Staff Report & Recommendation

Design Review Board

SUBJECT: **DRB19-0459**
5630 Pine Tree Drive

DRB19-0459, 5630 Pine Tree Drive. An application has been filed requesting Design Review Approval for the construction of a new two-story residence to replace an existing two-story architecturally significant pre-1942 residence including one or more waivers.

South elevation of 5640 Pine Tree Drive, B0604545

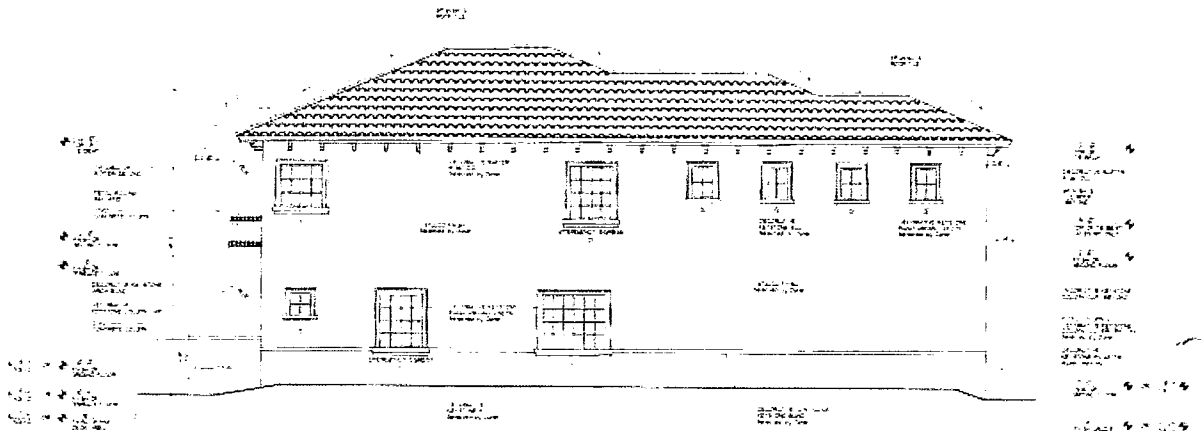
The applicant is also requesting a waiver pertaining to the north side open space. The elevation walls of the side two story residence measures 58'-6" in length plus the framing rear terrace elements, but the Code requires the open space provided along a side elevation, whether required or not, to be at least 75 percent of open space area to be sodded or landscaped previous open space, and also limits the height of the open spaces to the maximum elevation height of the adjacent yard, which is 6.63' in this instance. The architect has configured the space at 8.5' NGVD to be more planar with the interior space of the first floor. The only affected property, the neighboring residence to the north, was built in 2006 designed in a "Mediterranean Revival" style of architecture without DRB review, pursuant to B0604545. This structure has a two-story uninterrupted elevation that measures 68'-0" in length with a 8'-0" side setback to the shared property line.

Staff finds that the design of the home successfully minimizes its impact on adjacent side neighbors and the design of the open space has been configured to endeavor the intent of the ordinance. As such, is supportive of the waiver.
